SUNSET ROAD
109C-A-37

CLIFF ISLAND

APPLICATION FOR PERMIT

SITE PLAN REVIEW

PLAN OF PROPERTY
SHOWING 2 LOTS TO BE CONVEYED BY
WILLIAM THOMAS HEATH
CLIFF ISLAND
PORTLAND, MAINE

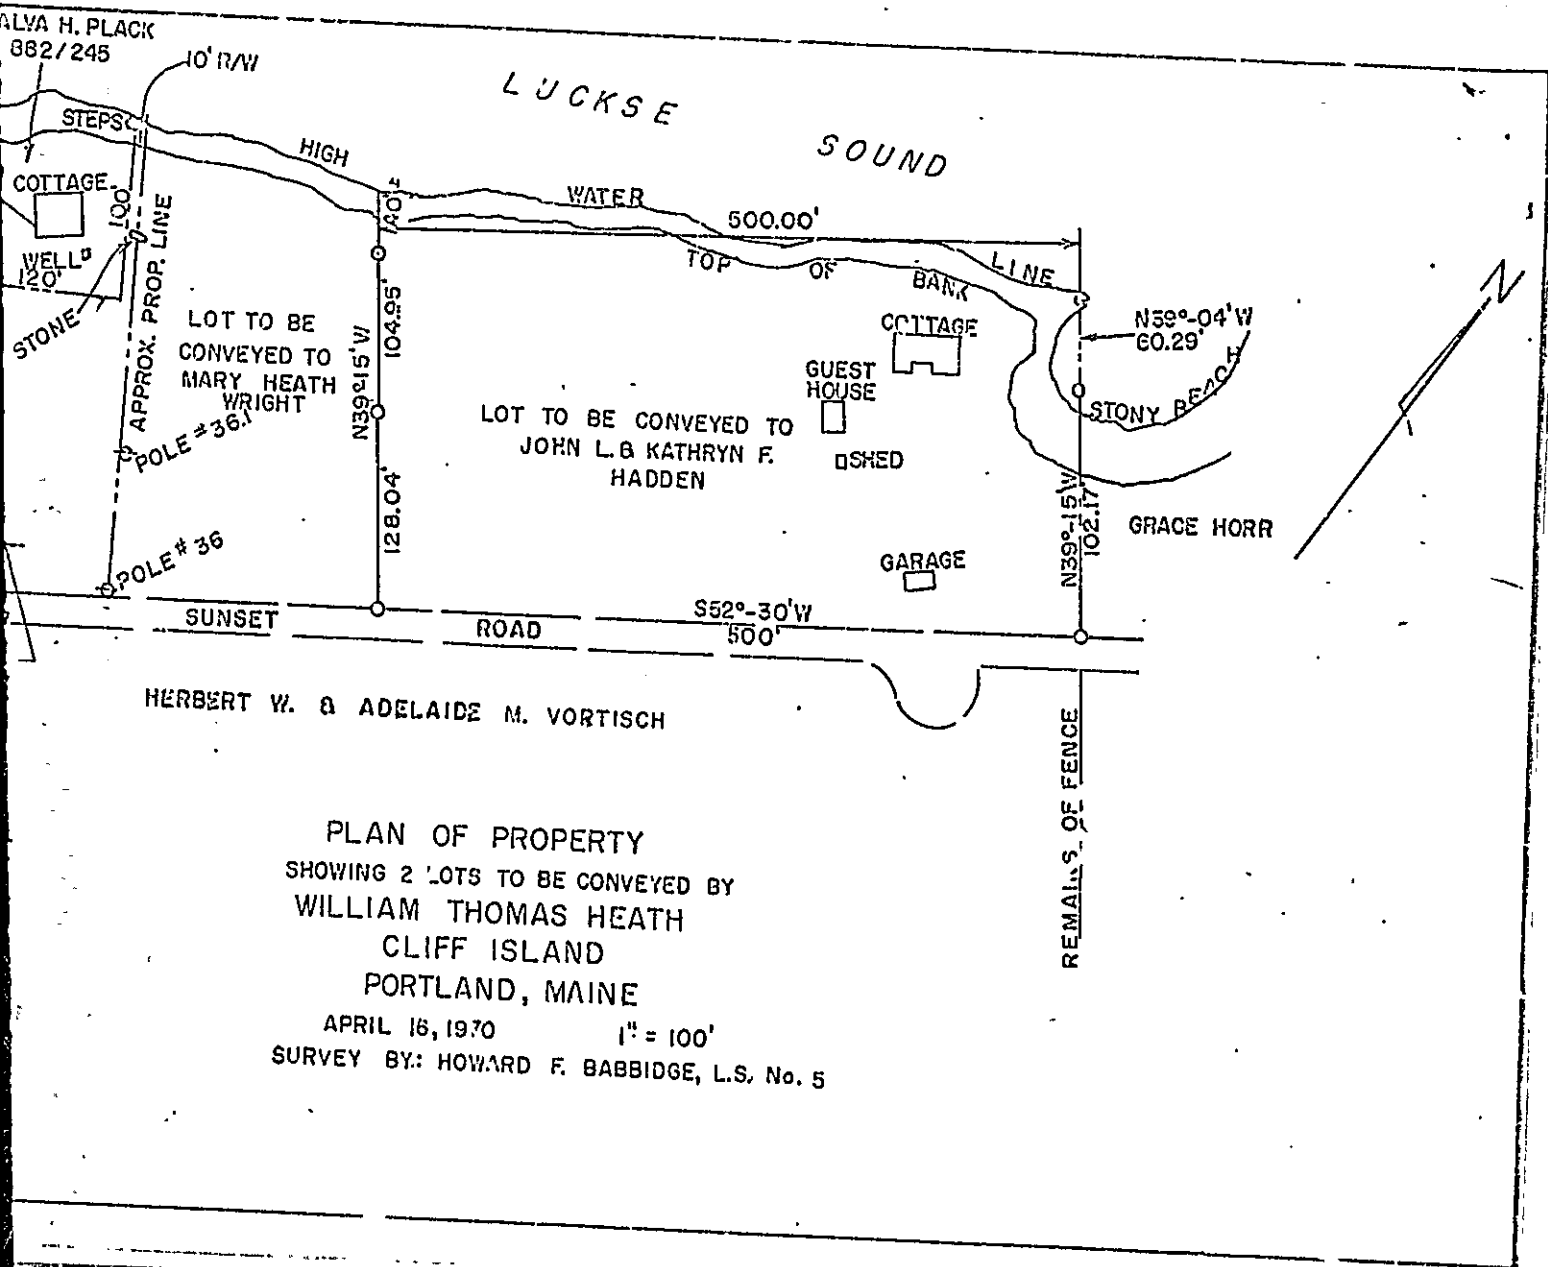
REASONS: The maps approved by the Planning Board showing flood prone areas identify the site for the proposed building to be flood prone up to 50 feet from normal high water. While the very rough map shows the proposal to be 75 feet from a section of the shoreline, it appears to be 45 feet from another section of the shoreline. Also, it cannot be determined whether the line shown is normal high water or otherwise. The Department of Building and Inspection Services should request further information regarding Attach Separate sheet necessary to it in detail before issuing a permit. If the building is in a flood prone area, it must be adequately flood proofed. Also, there is some ambiguity as to whether the septic system is existing or proposed.

FLOOR PLAN

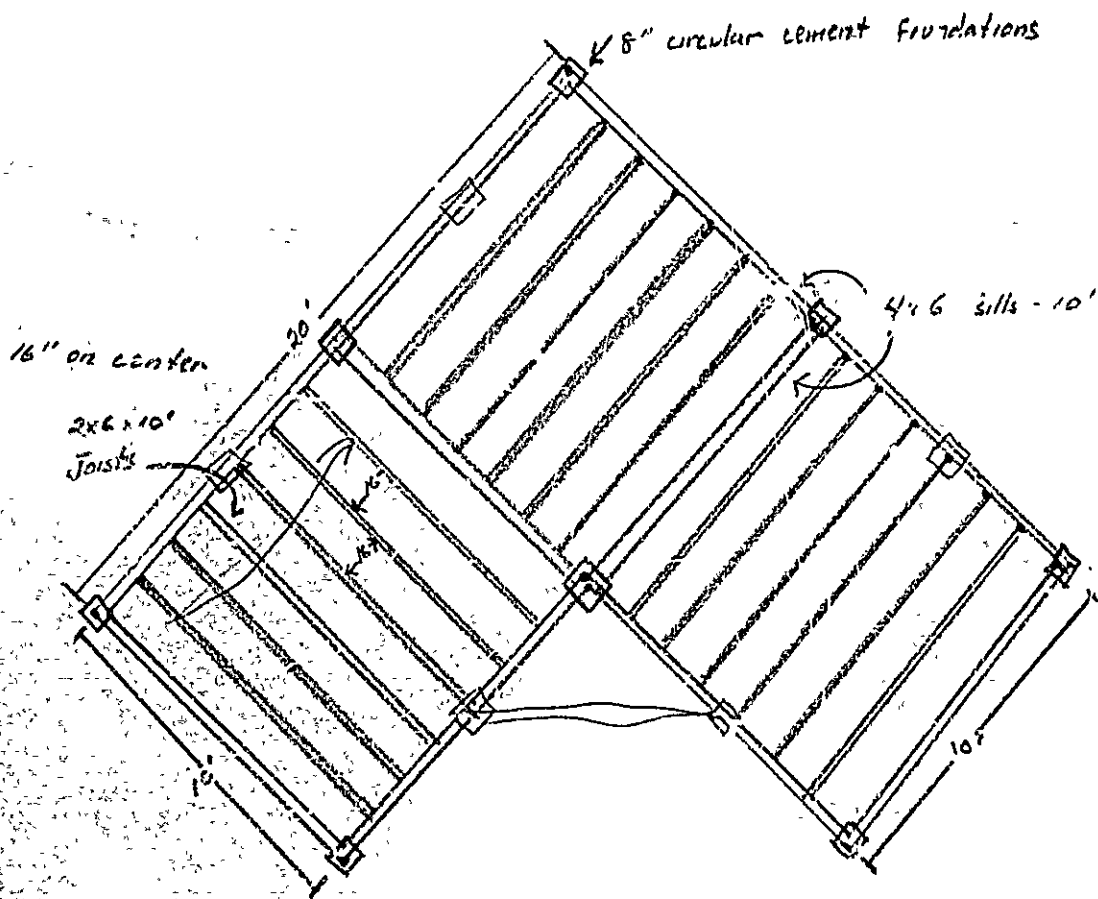
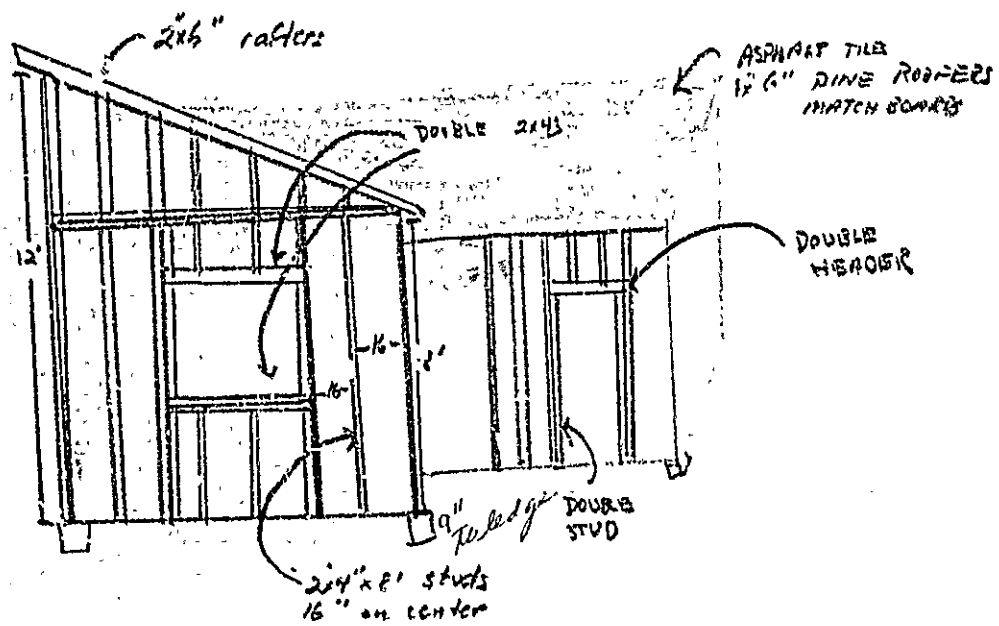
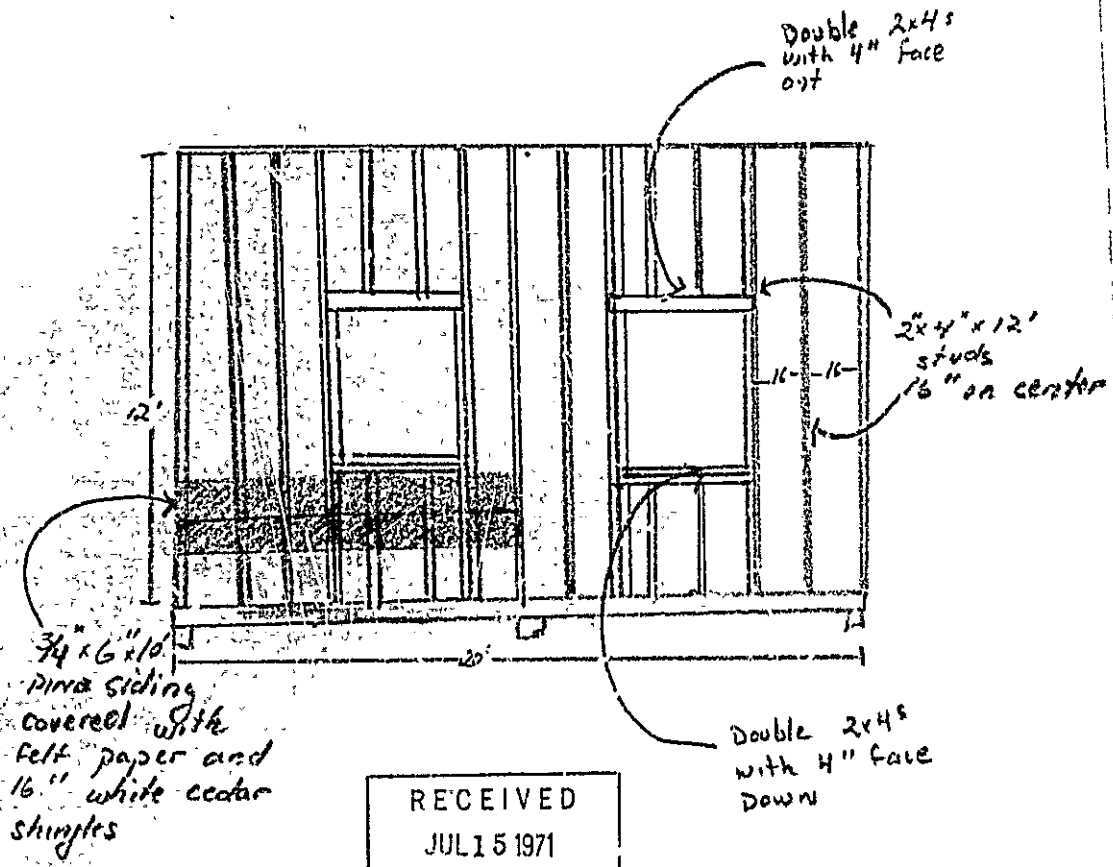
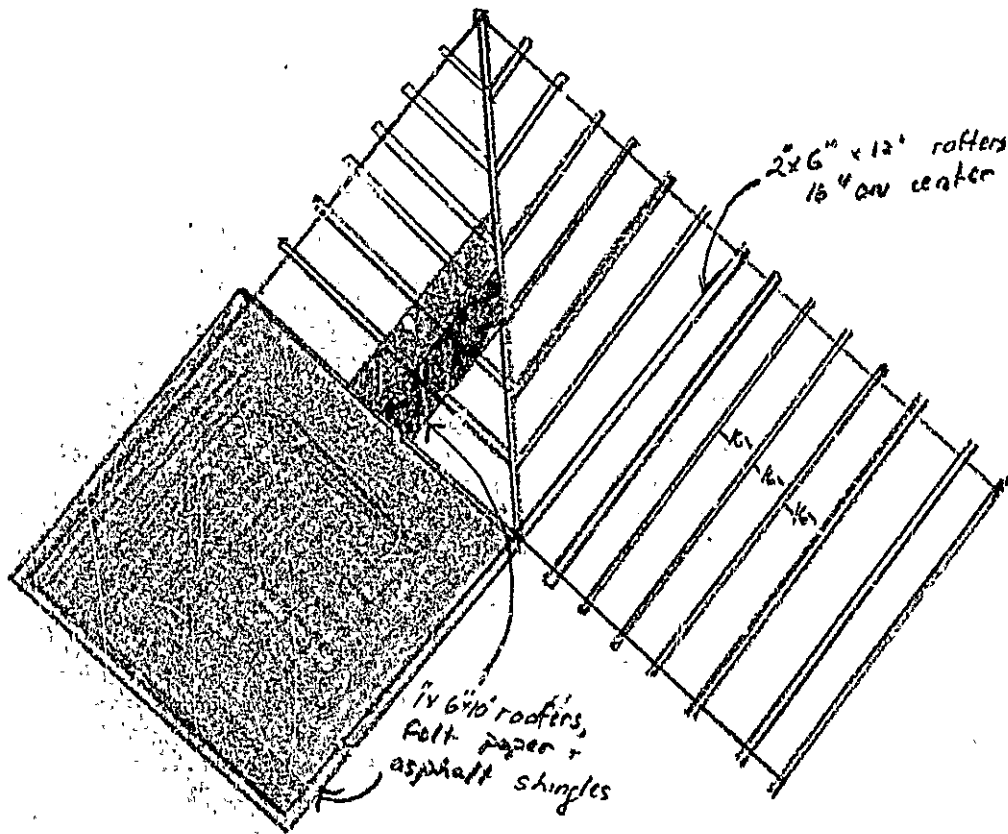
Permit to construct a frame cottage 20' x 20' x 10' as per plans is issued herewith subject to the following Building Code requirements:

1. Please bear in mind that 9" diameter sonotubes are required for the foundation and are to extend to ledge or at least 4' below grade.
2. The floor timbers are required to rest on a 2x3 nailing strip or to rest on top of sills.
3. The long valley rafter is required to be doubled where it goes from outside corner to point of intersection.
